BARNSTABLE TOWN

Notes on an ex-BR(S) Signal Box Diagram

These notes relate to a copy of a signal-box diagram for **Barnstaple Town** provided some years ago to the Signalling Record Society (SRS) from the microfilmed records of British Railways (Southern Region) (BR(S)). A scanned image of reduced quality is included in this document for ease of reference, but access to the original would be required for a more detailed study of some of the items mentioned below.

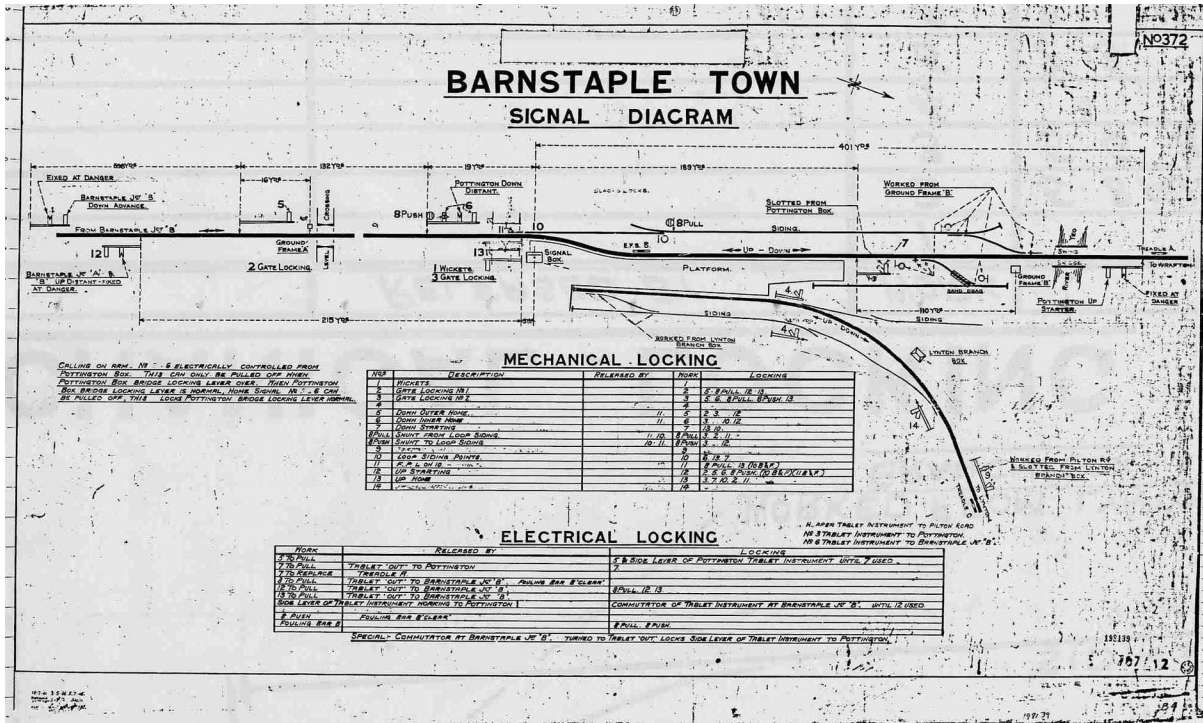
1. Date. At first glance the diagram would *appear* to date between 1923 and 1935, as it shows the L&BR still in place with its signals slotted from the SR box. Yet the diagram has amendment dates from the 1940s in the bottom left-hand margin, the 'West' box at Barnstaple Junction has been re-designated as 'B' (a change which took place in October 1949), the sand-drag (provided after closure of the transfer siding) is in place at the north end, and there is evidence of a BR(W) 'S..../12' number in the bottom right-hand corner. All these items suggest that the diagram had been maintained until at least the early-1960s, but why then did it continue to show so much of the former L&BR installation? Had someone perhaps dutifully carried out various amendments at different times after 1935 without realising that the diagram had not been amended previously to reflect the closure of the L&BR?

The 'negative date' of the diagram in the bottom right-hand corner *appears* to be 1917. Given that the diagram has 'residual traces' of items known to have existed in the original 1898 installation, but subsequently altered at an unknown later date (but certainly by *circa*-1925), this does help to provide a 'not before' date of 1917 for such changes, which otherwise would not have left amendment traces. The reason for the new drawing is unknown, but it *may* not be any more significant than perhaps (say) the addition of the Electrical Locking table or simply replacement of a worn original.

2. Diagram Number. The diagram bears the number 372 in the top right-hand corner, but there are references to 343 in the amendment details in the bottom left-hand margin. There is evidence of a BR(W) 'S' number (7??) in the bottom right-hand corner, but it is believed that the replacement BR(W) diagram for the 1967 alterations was numbered S3519. Given that this diagram came from a BR(S) source, then the *assumption* is as follows:-

3. Slot levers. In the original 1898 installation lever 4 was the Down Distant, 14 was the Up Distant and 9 was a 'safety bar' situated between signals 5 and 6. (It is not known if these levers were already spare by the time that they were re-used for 'slots' on the L&BR signals, or were changed from their original functions for that specific purpose, but there is a *presumption* that the latter situation was the case.) Examination of the 'Released By' column in the Mechanical Locking table shows evidence of deleted entries for 4 and 14 that are consistent with their original use as distant signals.

However there is evidence also of deleted entries in the 'Locking' column, which is not something to be expected normally for distant levers. Those entries *appear* to show that 4 locked 14, 9 locked 14, and 14 locked both 4 and 9. All those entries would be consistent with the *assumed* locking requirements for the period when those levers worked slots on the L&BR signals (*see note below*). However, none of the entries for levers 4, 9 or 14 have any information in the 'Description' column, which – combined with the fact that the 'Locking' details have been erased – would suggest that the Mechanical Locking table has been amended *after* the closure of the L&BR in 1935. In which case, why are the slot numbers still marked against their respective L&B signals?

4. Down Outer Home (5). This signal was renewed on 21-July-1925 (SR Signal Instruction 23/1925). The SI states that the existing 'C' and 'T' indicators (for the Permanent Speed Restriction over the River Taw viaduct) were re-fixed on the new post, and traces of what are *presumed* to be those circular indicators are evident on the diagram on either side of the lower part of the post. The PSR indicators were abolished on 15-April-1931 (SR SI 13/1931). The Down Outer Home was renewed again on 5-October-1948 (SR SI 37/1948).

The 'Calling On' arm under the Down Outer Home was abolished on 21-July-1925 (SR SI 23/1925) when the Down Outer Home was renewed. The 'Calling On' arm under the Down Inner Home remained in use until both it and the Down Inner Home were abolished as part of the 1967 alterations. The diagram shows the arm below the Down Inner Home and there is 'trace' evidence for the arm below the Down Outer Home. A careful examination of the block of text to the left of the Mechanical Locking table will show further 'trace' evidence where the text has been amended to delete entries for arm 5 and to change other words from plural to singular forms.

6. Safety Bar (9). In the 1898 installation there was a mechanical 'safety bar' installed about mid-way between the Down Outer Home and Down Inner Home signals and this was worked by lever 9. (A remnant of the erased '9' can be seen on the diagram close to the gap in the track.) Bearing in mind the alterations that would have occurred to the Mechanical Locking table for the changes relating to the later 'slot' levers, it would appear from the residual traces in the table that the reversal of lever 9 was required as a release for levers 8PULL and 13. (One may *presume* that, when the lever was reversed, the bar lifted and then fell again.) There is some evidence, but less clear, that lever 9 was locked by the use of 5, 6 or 8PUSH.

7. Loop Siding Points. In the 1898 installation the facing point leading into the loop siding was worked by lever 10, but the trap point at its exit was worked by lever 11. Both points had Black's 'economic' FPLs and traces of the deleted phrase '*Blacks Locks*' can be seen on the diagram just above those points. (A similar arrangement existed at the north end of the loop siding, controlled from GF 'B'.) It is not known why this lever arrangement was used, nor when it was altered, nor whether the alteration took place as part of some overall package of locking changes concurrent with the provision of the 'slot' levers.

reversal of lever 10 if the siding connection was fouled by a train on the platform line. However it is clear from the Electrical Locking table in the diagram that the later EFB had a different function, namely to lock lever 8 for the associated ground-signals. It is curious to note that, according to the Electrical Locking table, although the EFB locked both 8PULL and 8PUSH functions specifically, only 8PUSH is listed with the relevant 'Released By' requirement for the EFB to be 'clear' – there is no similar mention for 8PULL.

The diagram omits any ground-signal north of the ground-frame, and also the one in the 'six foot' by the Up Starting, yet shows all the others, so clearly there is some inconsistency here and it would be difficult to make an accurate assessment of the diagram date from that detail. No evidence has been found yet to suggest that any ground-signal was in fact mounted *on* the post of the Up Starting, as shown on the diagram, but – purely as speculation – it *might* have been a *post*-1940 change.

9. Sand Drag. The drawing marks a sand drag as part of the crossover connection to the up side 'transfer' siding, in a location which clearly makes the crossover unusable. According to SR SI 6/1940, the transfer siding and its associated ground signals were abolished on 3-April-1940, but the facing point on the main line was left in place to lead to a 40-foot sand drag. This is another example of a *post*-1935 amendment to the diagram which is incomplete, as the sand drag has been added but neither the siding nor its shunt signals have been erased.

was on the platform side of the platform line, but at some unknown date that signal was moved to the outside of the run-round loop siding. Then on 28-August-1929 (SR SI 33/1929) the signal was renewed and re-located on the platform, where it remained until 1935. There is no known photographic evidence, nor anything in SI 33/1929, to suggest that two separate signals were in use at any time, nor does there seem to have been any need for such an arrangement. It is *assumed* therefore that this is simply a drawing error.

11. L&BR FPLs. The L&BR used 'economic' facing point locks. A FPL is shown on the facing point close to the L&BR's Up Home, which leads into the run-round loop. There was also an FPL on the facing point close to the L&BR's Down Starting, which lead into the 'transfer' siding, but that is **not** shown. A FPL *is* shown also on the trailing point of the release crossover in the platform road, but there is no photographic evidence for that, nor would it appear to have been necessary. The reasons for these apparent inconsistencies on the diagram are not known.

12 L&BR Functions. The diagram marks specifically that the engine release crossover points are "*worked from Lynton branch box*", yet there is no similar annotation for the points for the 'transfer' siding or at the entrance to the loop. Likewise, the diagram marks that the lower ringed arm under the L&BR's Down Advanced Starting was "*worked from Pilton Rd and slotted from Lynton branch box*", but there is no equivalent annotation for the working of the slots on the Down Starting and Up Home from the ex-L&BR box.

A close examination of the diagram suggests that there had been a further instance of the phrase "*worked from Lynton branch box*" written in the space just below, and to the right of, the L&BR signal-box. This has been deleted along with the various 'arrows' which appear to have led from it towards the other L&BR signals and points. It is *assumed* therefore that this is another example of the diagram having been subject to an incomplete amendment at some *post*-1935 date.

The lower ringed arm was added on 30-August-1927 (SR SI 22/1927). It is unclear whether the figure '9' against the signal is meant to apply to both arms, or just the upper one, but there are faint traces of markings which *could* support the former arrangement. Certainly it has been *assumed* previously that the ringed arm also would have been slotted by '9' and therefore had three slots.

It is curious therefore that the lower arm alone is marked specifically "*worked from Pilton Rd and slotted from Lynton branch box*", as use of the term 'worked' tends to indicate that the signal is **not** controlled by the box on whose diagram it appears (in

this case, the ex-L&SWR box). It is *possible* therefore that in fact lever 9 had no control over the ringed arm, but in that case one must question why it was that the signal was slotted from the L&BR box (given that this slot must have been provided in 1927 or later) but not the ex-LS&WR box which was now the block-post. It is possible of course that interpretation of the available information has been confused by another example of a partial amendment.

14. Treadle 'A'. This treadle released a back-lock on lever 7. The treadle is shown on the diagram simply as being somewhere north of the swing-bridge. On an early GAP drawing it is shown as being between the south end of the swing-bridge and the facing point into the north end of the loop siding, but it has not been possible to find any 'trace' evidence on the SR drawing. A 1960s BR(S) diagram for Pottington signal-box includes a treadle identified as 'C' almost directly in front of GF 'B'. The precise position of this treadle therefore remains unclear.

15. Treadle 'C'. This treadle is marked on the L&BR line in advance of the Down Advanced Starting signal. Its purpose is unknown, as there is no other reference to it on the diagram, so it is unclear whether it served a function at Barnstaple Town or Pilton or both. It is *possible* that it may have been added in SR days to release a back-lock on the Down Advanced Starting slot 9, and therefore could have been listed in a deleted entry in the Electrical Locking table (see comments elsewhere in these notes about the Electrical Locking table).

For both 8PULL and 13 the 'Locking' entry for '2' is out of the normal ascending sequence and *appears* therefore to be a latter addition (re-using a space in the sequence in the case of 8PULL). Given that both signals used to be released by 9 (when that lever worked the safety bar), then *perhaps* it had been the case that 9 locked 2, so the direct locking between 8PULL/13 and 2 only became necessary after 9 was converted for use as a L&BR 'slot'? However there is less obvious evidence for any changes in the 'locking' entries for lever 2.

17. Electrical Locking Table. This shows evidence of some alterations in the BR period, as Barnstaple Junction West has been amended to 'B' in two places. There is a blank line (above the entry for 8PUSH) which has traces of a deleted entry where the first character in the 'Work' column *appears* to be '9'. As the entries in the lower part of the table appear to relate to later arrangements, then it is considered that any entry for '9' is more likely to date from the period when it was a 'slot' lever rather than the earlier safety bar. It is *suggested* therefore that this entry *may* have been *either*

18. ETT instruments. Block working to Pilton is listed as using 'Hopper No 1' instruments. This is a description unknown other than in SR documents about the L&BR line, whereas photographic evidence shows that in fact the L&BR used Tyer's No 7A instruments. Given the rarity of that pattern in the UK, it is *assumed* that the 'Hopper' description was a local term for what was otherwise an unknown type of instrument in the area.

19. Pilton. There are two places on the diagram where the signal-box at Pilton is described as 'Pilton Road' or 'Pilton RD', whereas other documents of the SR era refer to it as 'Pilton Yard'. Although also described variously as 'Pilton Bridge' or just 'Pilton', no other instances of 'Pilton Road' are known.
